Fixing of the check card functions coral and sapphire

→ Starting from serial number: 13001734 dated 14/05/13

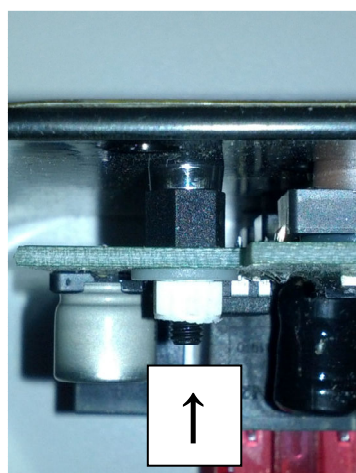
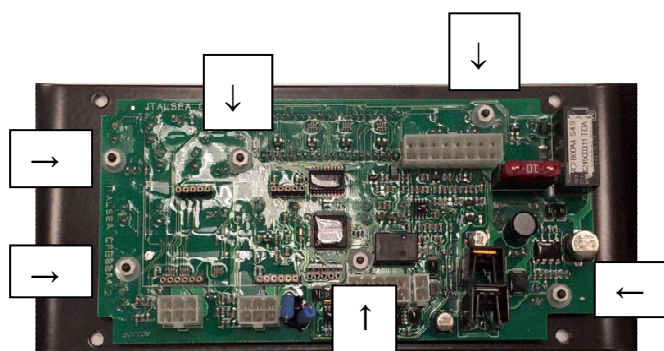
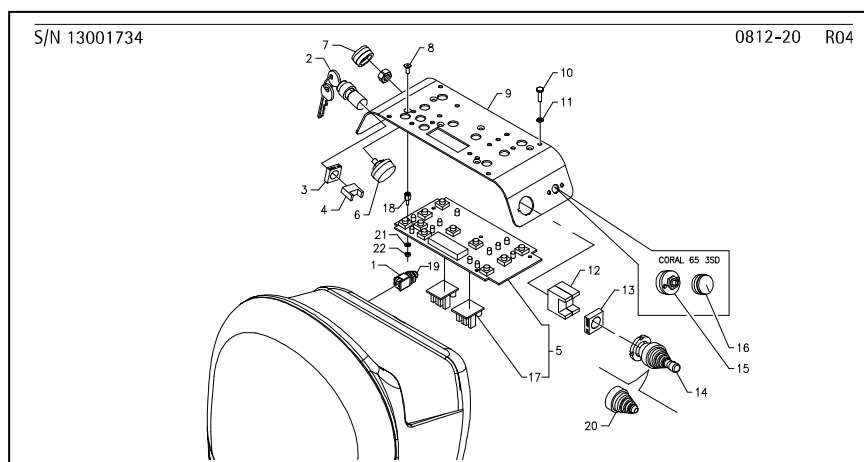
The pressure couplers have been replaced (63705003, pos. 18).

We have verified that, the pressure couplers did not assure the correct fixing of the check card functions for a long time, creating some problems while pressing the buttons on the control panel. These couplers have been replaced by hexagonal spacers.

The new spacers can be sent as spare parts for the machines already produced, as long as they are sent complete with the washer (pos. 21) and the nut (pos. 22).

Take off:

pos. 18 No. 6 63705003 coupler check card

Add:

pos. 22 No. 6 60210304 nut M3 nylon

pos. 21 No. 6 60303005 washer 3,2x9x0,8 nylon

pos. 18 No. 6 63705004 hexagonal spacer
